# PSL Frequency Stabilization

## Frequency Stabilization Servo Rev. F 01

### Change Summary for Rev E & Rev F Boards

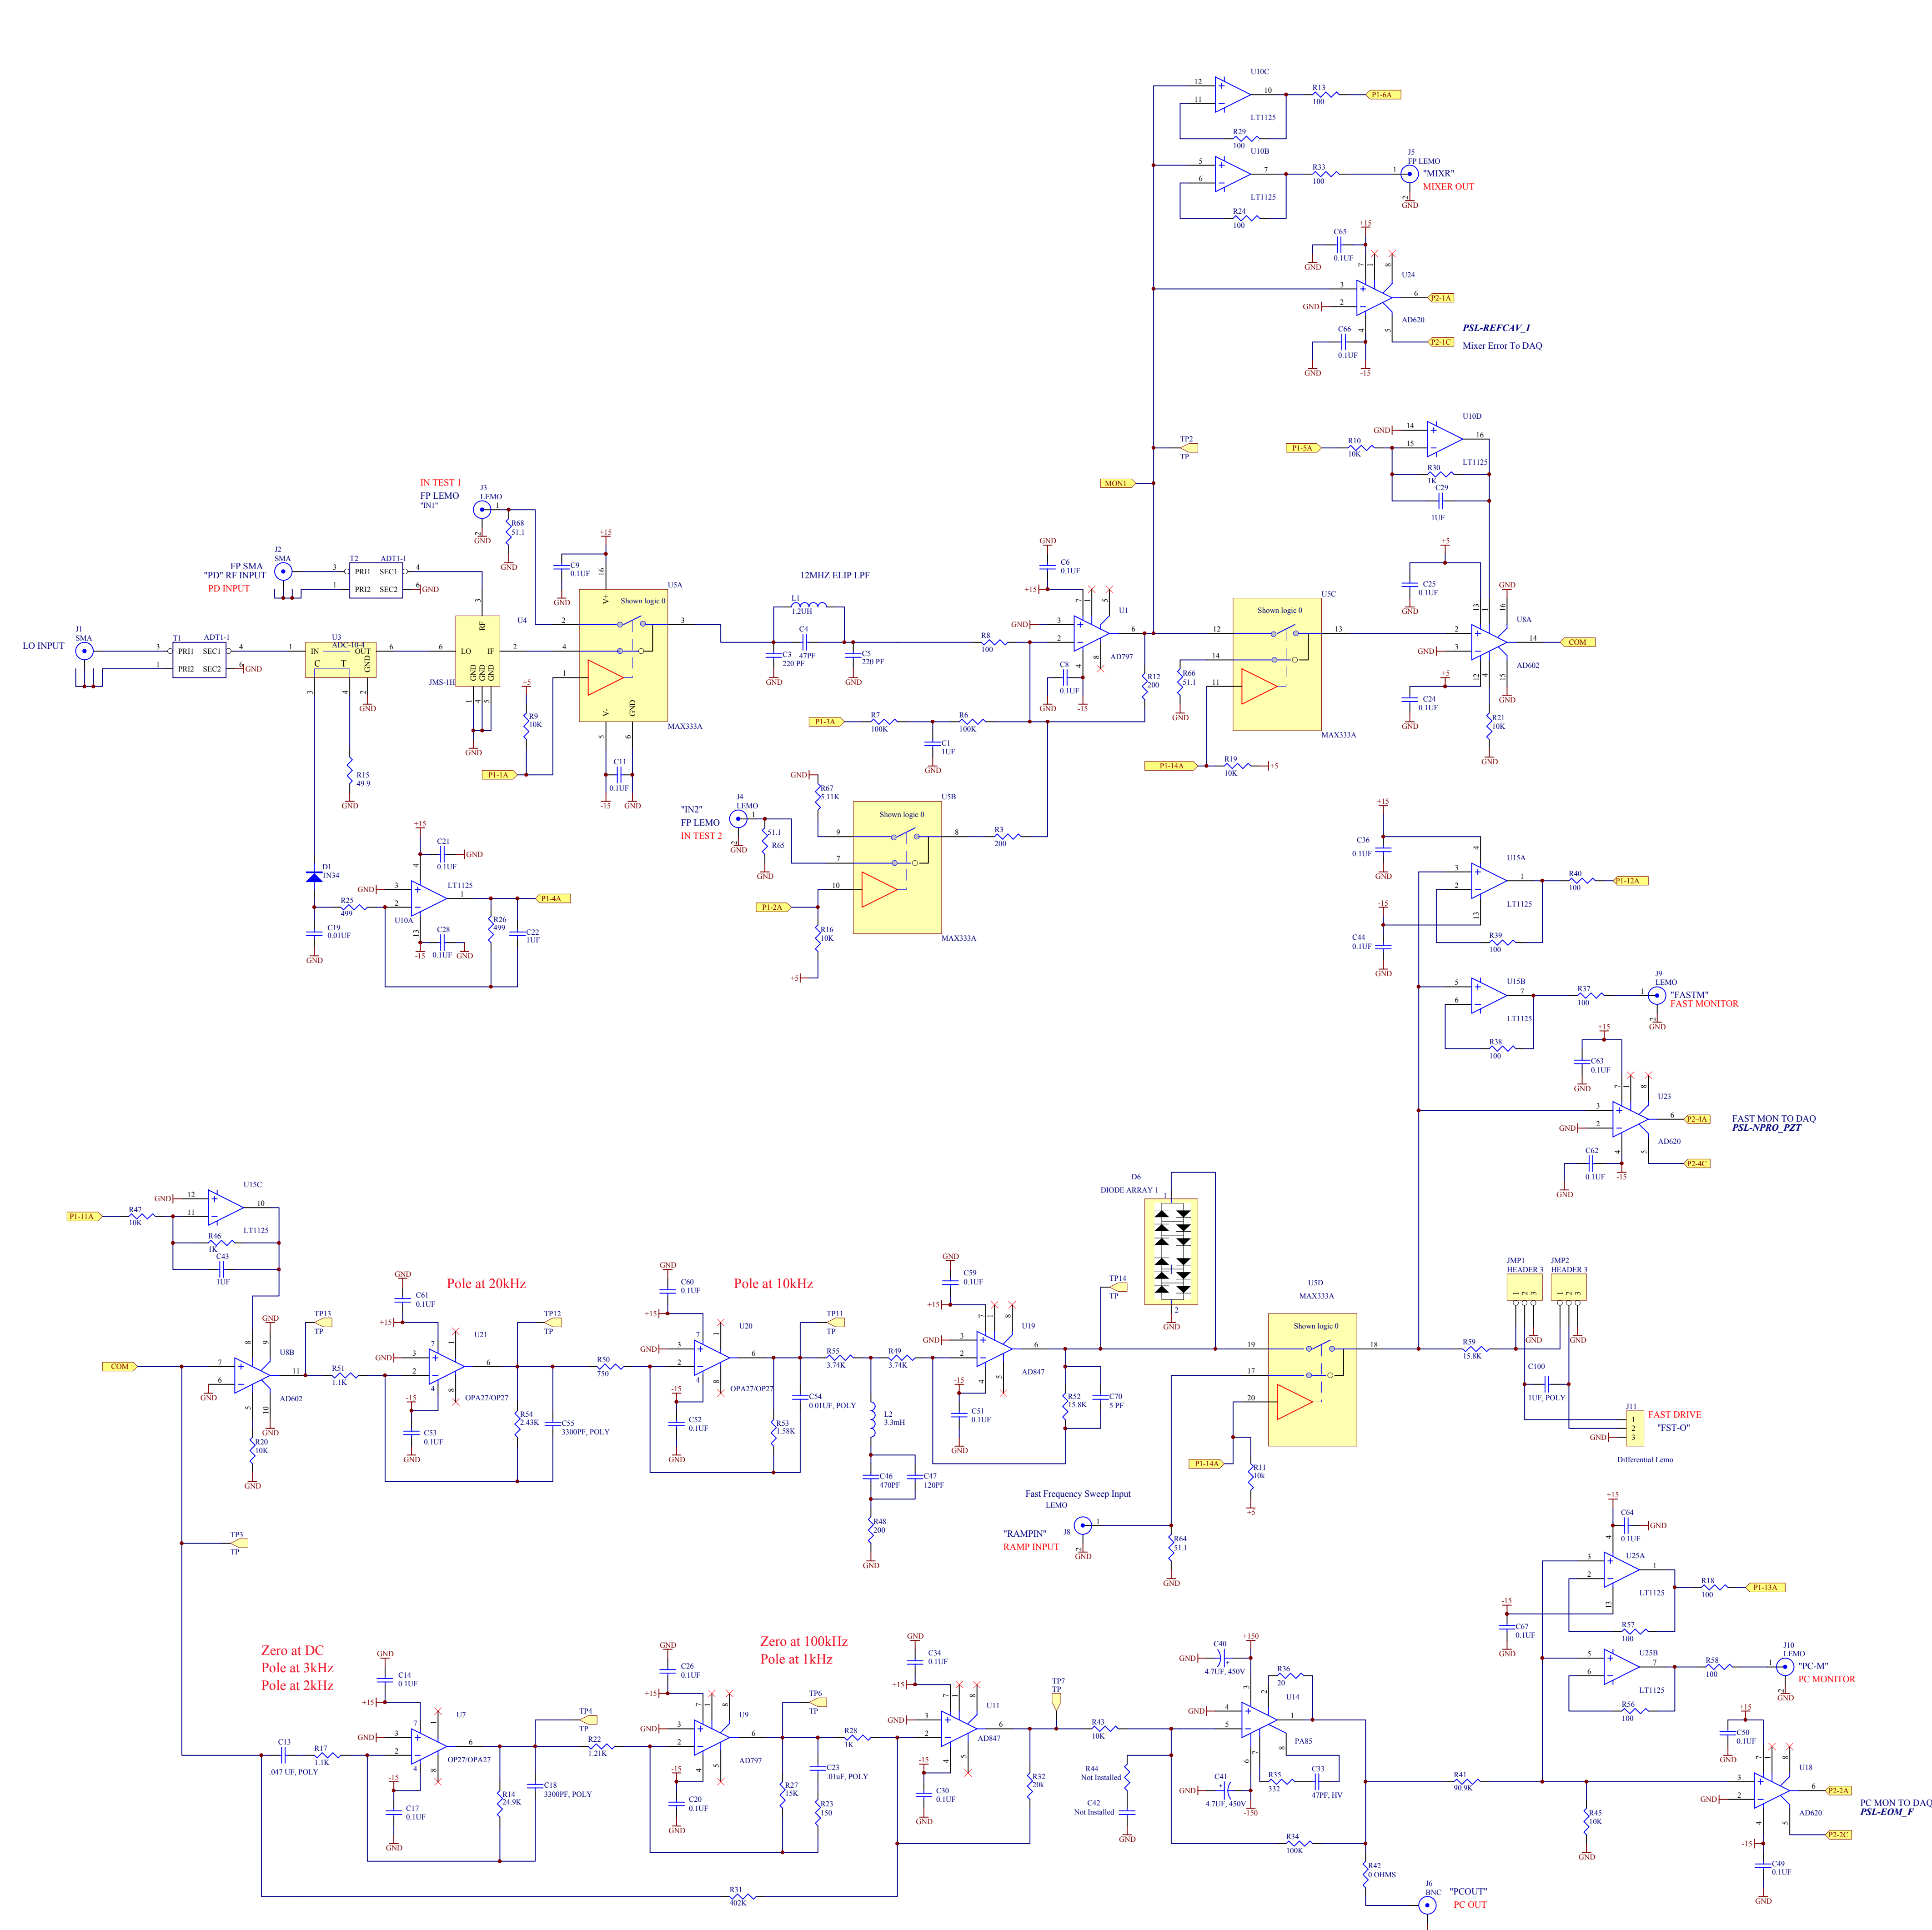
- REV E UPDATES...**
- \* U7 was an LT1028 and is now an OPA27
  - \* R31 has been changed from 100K to 402K
  - \* The capacitor in parallel with R52 across U9 has been eliminated from this schematic
  - \* R44 and C42 are not installed
  - \* C16 formerly in series with C18 has been shorted out.
  - \* 1u6l External Cap in the Fast Drive area has now been formally designated C100
- REV F UPDATES...**
- \* 51 ohm resistors added from the following points to ground: J4-1, U5-14, J5-1, J8-1
  - \* 5.11K added from U5-9 to ground
- REV F01 UPDATES...**
- \* 1 uF caps were added on each of the regulators
  - \* 5 pF cap C70 was added across the feedback resistor of U19
  - \* P1-13A and P1-14A were interchanged on the Rev F schematic - typo only
  - \* U1 has been changed from an LT1028 to an AD797
